Access Compliance Report

Public Rights-of-Way (Curb Ramps)

Intersection ID: 22508	Main Street: KRISLYN_WOODS_PL	Cross Street: SEASCAPE_LN	Location: SE
ADA ID: C80EDA4147AC	Ramp Type: Directional	Initial Pass/Fail: Fail	Overall Compliance: No
Severity Score: 21.25			
Codes/Mitigation Info/Possible Solution		Field Measurements/Component Compliance

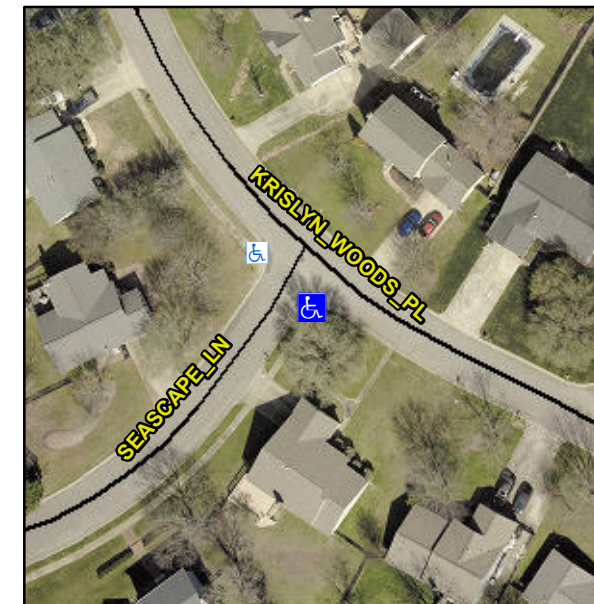
Compliance	Description	Data	Compliance	Description	Data
N/A	Ramp Length (in)	66.5	N/A	Grade Break?	N/A
No	Ramp Width (in)	46.5	N/A	Grade Break Slope (%)	0.0
Yes	Ramp Slope (%)	0.0	N/A	Grade Break XSlope (%)	0.0
No	Ramp XSlope (%)	6.0			
N/A	Flare Type LT	N/A	N/A	Flare Type RT	N/A
N/A	Flare Slope LT (%)	N/A	N/A	Flare Slope RT (%)	0.0
N/A	Flare Traversable LT?	N/A	N/A	Flare Traversable RT?	N/A
N/A	Landing Length (in)	0.0	N/A	DWS Provided?	N/A
N/A	Landing Width (in)	0.0	N/A	DWS Contrast?	N/A
N/A	Landing Slope (%)	0.0	N/A	DWS Length (in)	N/A
N/A	Landing X Slope (%)	0.0	N/A	DWS Full Width?	N/A
N/A	Landing Curb? (Y/N)	N/A	N/A	DWS Offset LT (in)	N/A
N/A	Shared Landing?	N/A	N/A	DWS Offset RT (in)	N/A
N/A	Gutter Ponding?	0.0	N/A	Gutter Slope (%)	N/A
N/A	Gutter Lip Ht (in)	0.0	N/A	Gutter X Slope (%)	N/A
N/A	Painted X Walk1?	No		Road Slope (%)	0.3
	X Walk 1 Direction	To W		Road X Slope (%)	0.0
	X Walk 1 Width (in)	N/A		Clear Space?	N/A

X Walk 1 Slope (%)	0.3	N/A	Clear Space to XWalk (in)	N/A
	X Walk 1 X Slope (%)	0.0	N/A	Storm Grate/Utility Hazard?	N/A
N/A	Ramp inside XWalk1?	N/A		Storm Grate/Utility Type	
N/A	Any Obstructions?	N/A			N/A
	Obstruction Type		Yes	Surface Condition? (G/P)	Good
			N/A	Curb Slope (%)	1.3

Remove & Replace Entire Ramp.

R304.5.1, R304.5.3
